Royal Botanic Gardens Kew Conservation and Research Nursery, Wakehurst

Section 73 Application: Design and Access Statement

Document number	286-A-R0002
Revision number	P2
Revision Date	25.09.2025

Isometric drawing of the scheme as consented with key reductions and omissions highlighted in red

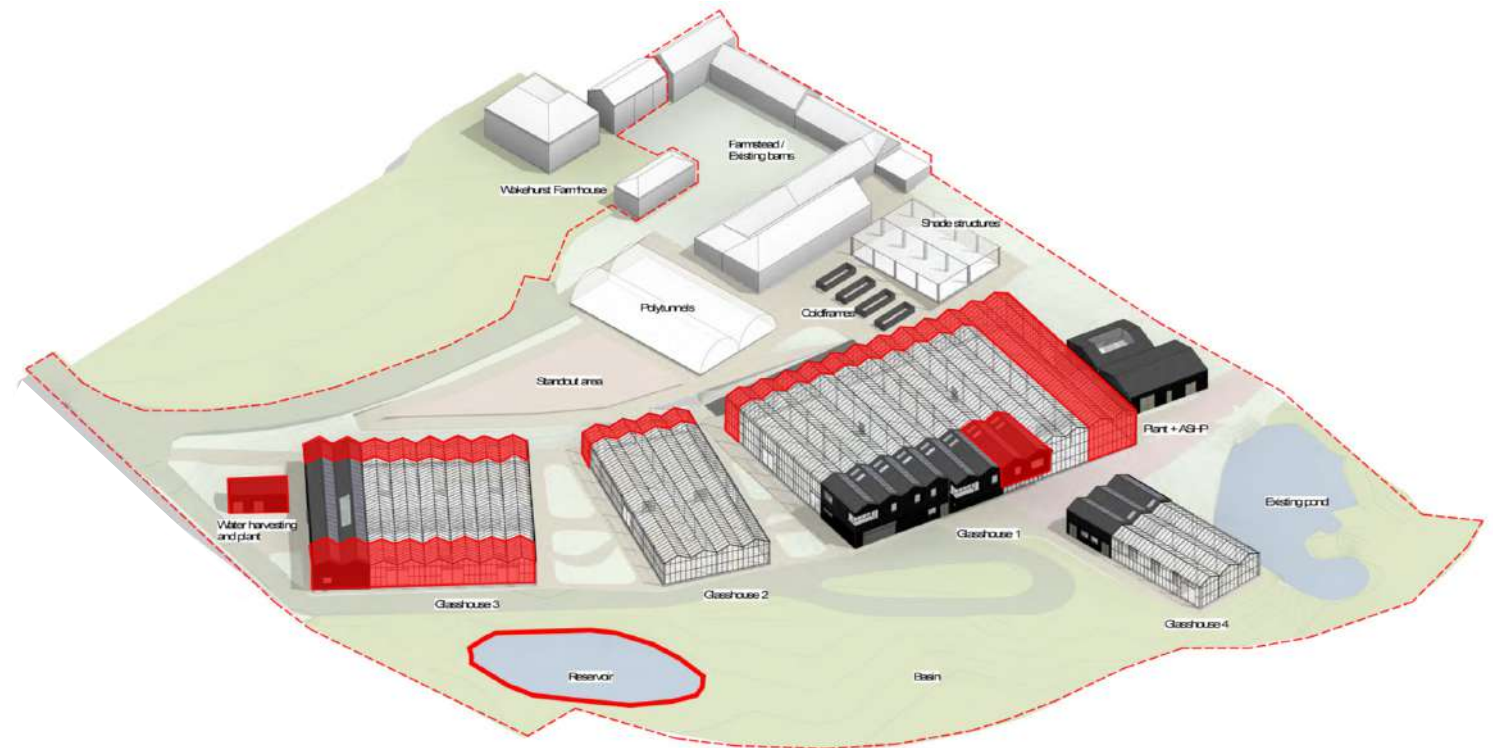
1. Glasshouses 1, 2 and 3 and corresponding adjoining ancillary buildings are reduced in size versus the consented scheme. This allows the project programme to be delivered more efficiently and also makes space for items 2 and 3. The upper storey of Glasshouse 1's ancillary building is omitted.

2. A softer transition is proposed between the upper and lower portions of the site, using more environmentally sustainable and less expensive earth retaining structures: A previously proposed concrete retaining wall and vehicle access ramp is omitted and replaced by planted slopes and low rock-filled gabion walls. This improves the landscape setting of the proposals and also helps to achieve biodiversity net gain requirements. Vehicles needing to transition between the upper and lower sites will use the alternative route already provided for in the consented scheme.

4. The surface water storage reservoir from the previous scheme is omitted. This is an inefficient way to store water for irrigation use suffering from evaporation losses and the energy cost of treating the water before it can be used for watering plants. Instead, above ground rainwater storage tanks are proposed in a visually screened location at the south end of the site (see item 9). Unlike the previously proposed reservoir, these store rainwater from the glasshouse roofs which can be used for irrigation (watering plants) with no additional treatment. Note that wet habitat is provided through other proposed landscaping features, and a woodland area is now proposed where the reservoir was previously shown resulting in enhanced biodiversity net gain versus the consented scheme.

Glasshouse 1 west elevation as consented

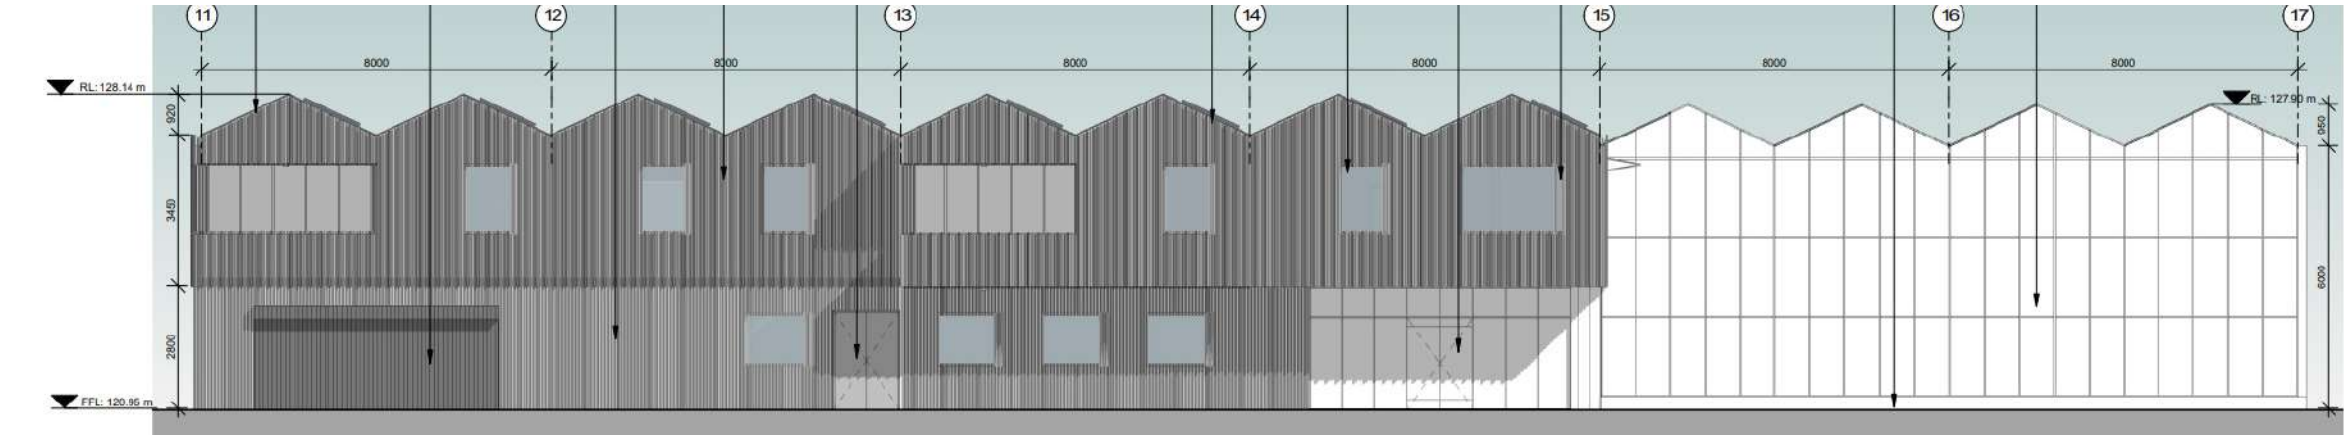
Design development has refined the elevational treatment, including changes to the sizes and locations of doors and windows and to the detailed design of the timber cladding. The previous cantilevered

portion of the upper storey has been omitted, as has the balcony and its folding screens. These were predominantly associated with the now-omitted permanent public facilities.

Designs for the glasshouse have been further developed also, with the locations and sizes of external sliding glass doors amended. Clear glazed, mechanically actuated opening ridge ventilators will be fitted on the roofs, and opening glass louvres will provide additional ventilation in the external walls - these were described in previous design submittals but their locations and extents have now been defined and drawn.

Glasshouse 2 elevations as consented with proposed reductions in building size highlighted in red

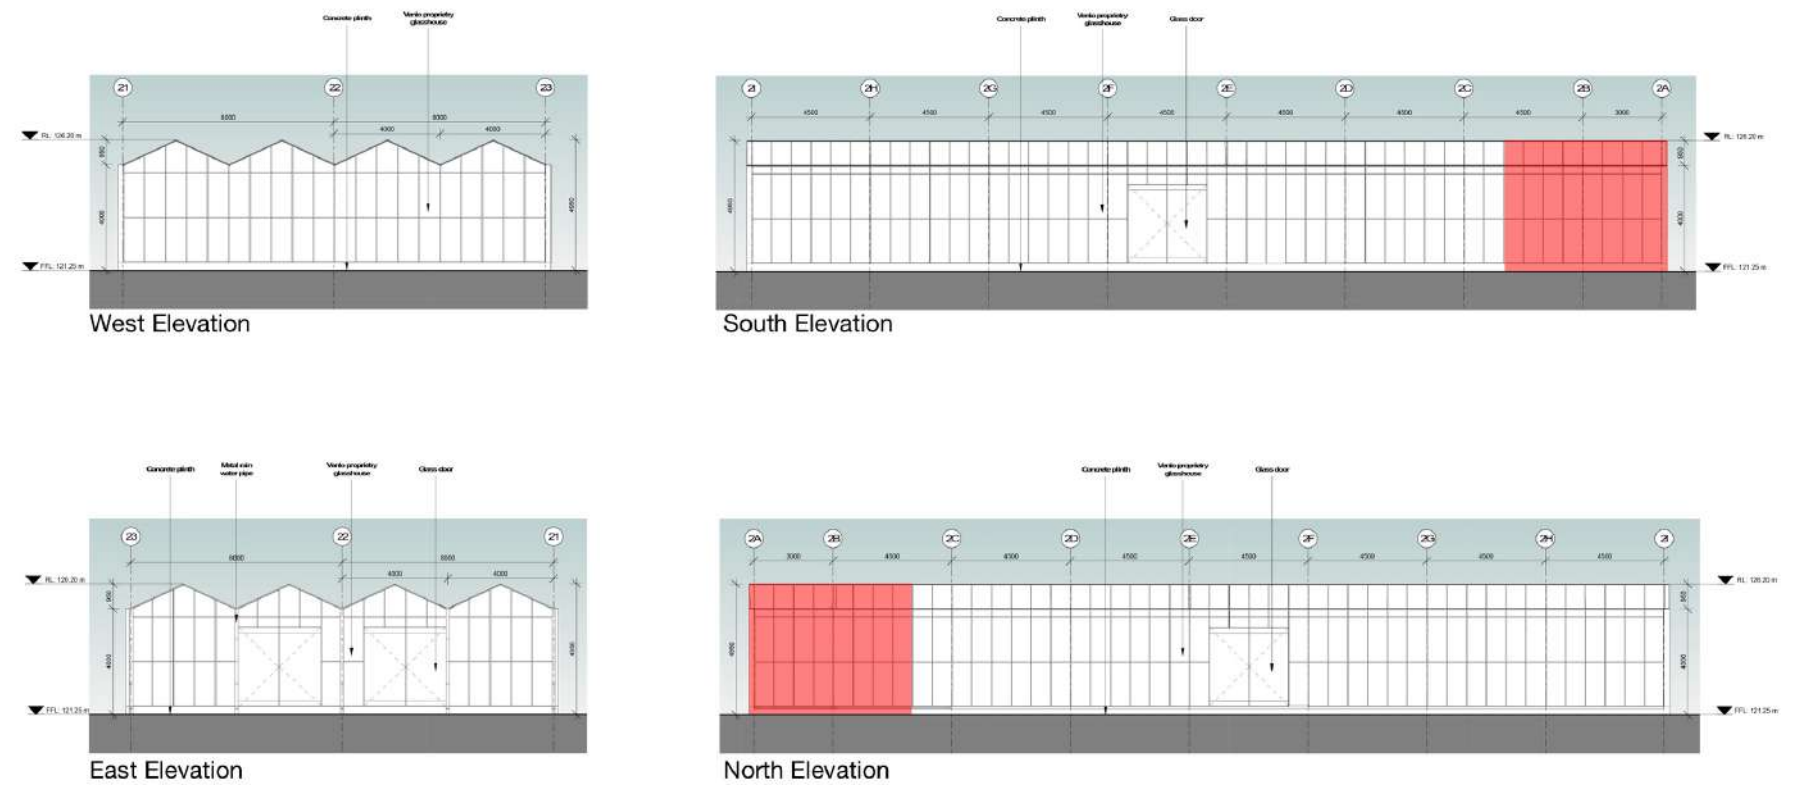
Glasshouse 2 is reduced in length and thus plan area versus its consented form. Its height remains the same. Similar to Glasshouse 1, the developed designs feature opening ridge vents to the roof, glazed louvre vents to the walls and amended metal-framed glass sliding doors.

Glasshouse 3 elevations as consented with proposed reductions in building size highlighted in red

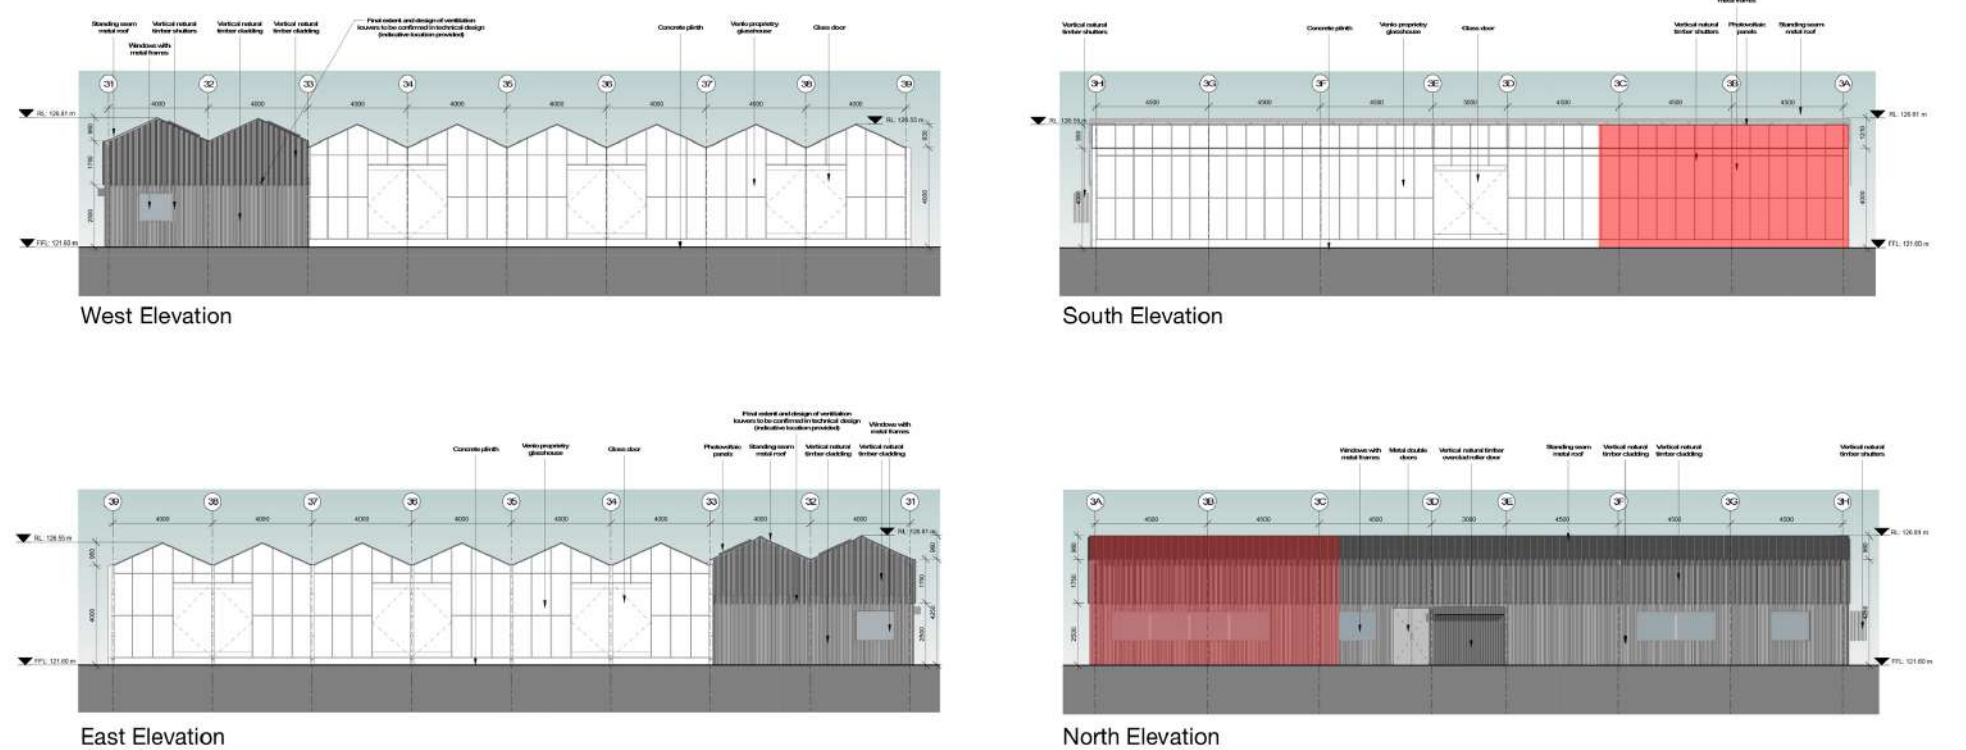
Glasshouse 3 is reduced significantly in plan area versus the consented scheme but remains similar in its general configuration. The timber-clad ancillary building houses similar functions except for the omission of the secondary staff kitchen since staff working in this glasshouse will make use of the facilities provided in Glasshouse 1. Similar design amendments to the building elevations / timber cladding are proposed as those described earlier for Glasshouse 1, including reconfigured glazing and doors. Some of the compartments will provide biological containment facilities. For this purpose, fine mesh netting will be added to some of the roof vents, and units containing mechanical extract fans and filters will be added to external elevations. The fans will meet the noise limitation criteria specified in the original approvals (Conditions 29 and 30).

Proposed landscape cross section showing revised management of site levels featuring wildflower planted slopes and gabion walls. This is similar to the strategy employed at the nearby Millenium Seed Bank (photo below).

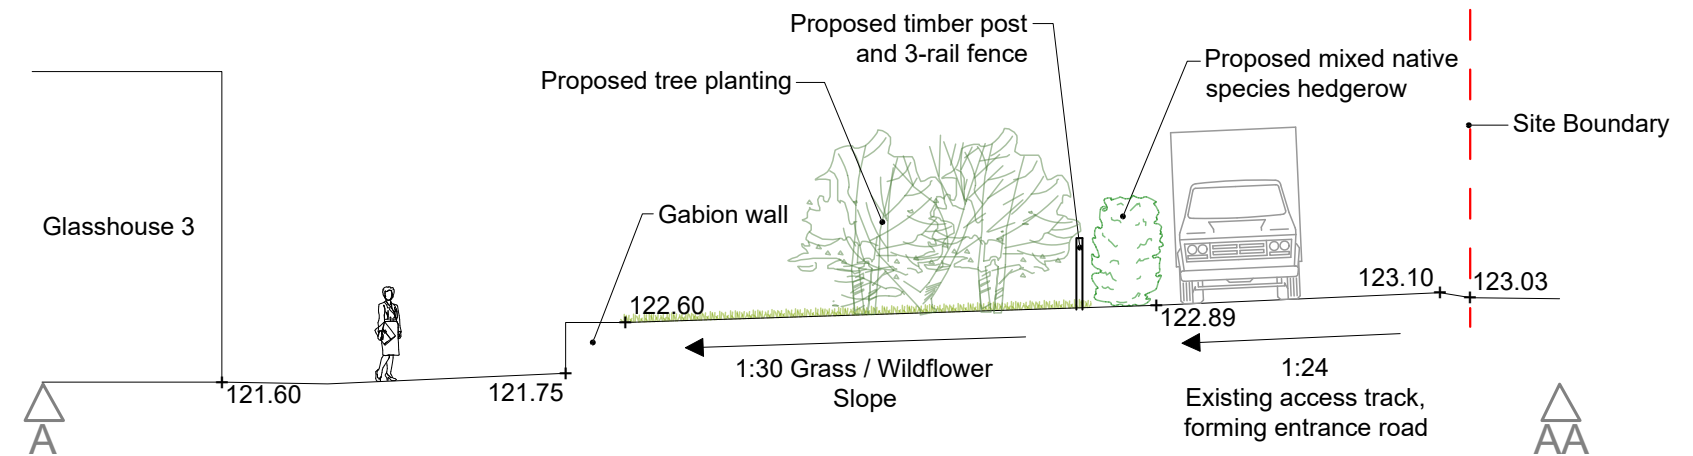
Previously proposed vertical concrete retaining walls have been omitted, with the reduced earth-retaining requirements now being handled by a mix of planted

batter slopes and rock-filled gabion walls (including partial fill of local material salvaged from earlier demolition works). This will enhance the landscape setting of the glasshouses versus the consented scheme, and result in reduced embodied carbon emissions.
